6.1 **1 VICTORIA AVENUE, ALBERT PARK**
LOCATION/ADDRESS: **1 VICTORIA AVENUE, ALBERT PARK**
EXECUTIVE MEMBER: **LILI ROSIC, GENERAL MANAGER, DEVELOPMENT,
TRANSPORT AND CITY AMENITY**
PREPARED BY: **PHILLIP BEARD, PRINCIPAL PLANNER
MICHAEL MOWBRAY, PRINCIPAL PLANNER**

1. PURPOSE

- 1.1 To assess a proposal to demolish the existing two storey building and construct a new three storey building, comprising a nine suite residential hotel above ground level (as-of-right) food and drink premises and basement car parking for five car spaces within car stackers.

WARD:	Lake
TRIGGER FOR DETERMINATION BY COMMITTEE:	Demolition of a significant graded building and more than 15 objections.
APPLICATION NO:	880/2019
APPLICANT:	SJB Planning P/L
EXISTING USE:	Vacant commercial and residential
ABUTTING USES:	Commercial and residential
ZONING:	Commercial 1
OVERLAYS:	HO 443
STATUTORY TIME REMAINING FOR DECISION AS AT DAY OF COUNCIL	Expired

Figure 1(BsBS): Building Portions.

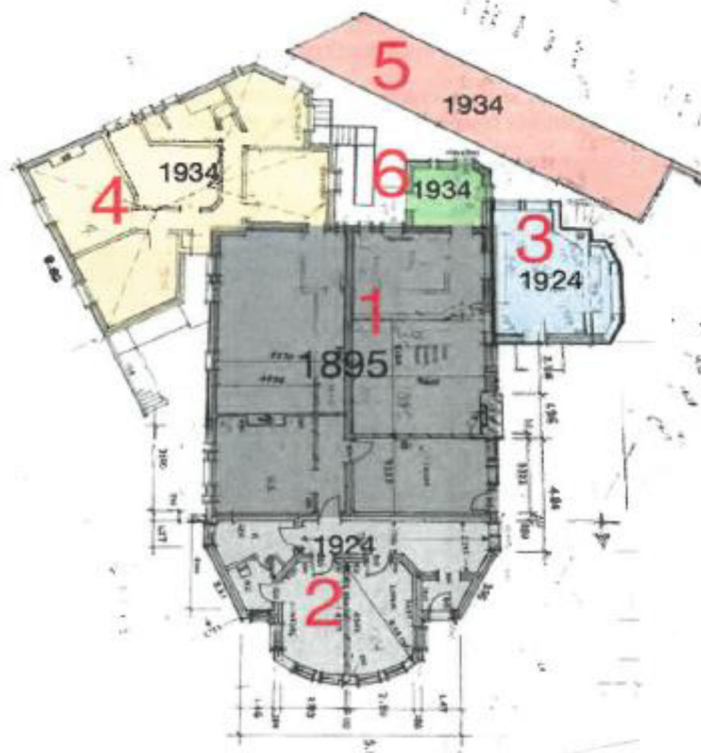
- 4.2 The matter was heard by VCAT and the Tribunal affirmed Council's decision to not support the application. Key reasons for VCAT's decision are found in the following paragraphs of the order, together with a map also extracted from the VCAT order depicting the various eras and 'sections' of the existing building.

Plans showing how the ‘**newly**’ (word added by planner) advertised design response references the historic built form in Victoria Avenue.

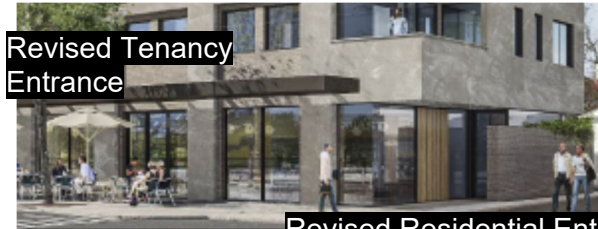
The architectural expression and detailing of the advertised design response has been greatly simplified and the unnecessary and distracting detailing has been removed, as shown in the images below.

- *It now presents a refined pallet of elements and a stronger pattern language that respects and is more appropriate to the historic context. The scale and rhythm of fenestrations has been rationalised and are now set within indents in the façade. This breaks the building down into vertical bays in a manner that is consistent with the heritage buildings on Victoria Avenue (see comparison images below). The array of awning types and materials have been consolidated creating a line that references the other awning in the street and provides pedestrian amenity. At the corner the awning has been removed to provide a clean and defined profile that is consistent with historic corner buildings in the precinct such as the Albert Park and former Windsor hotels.*
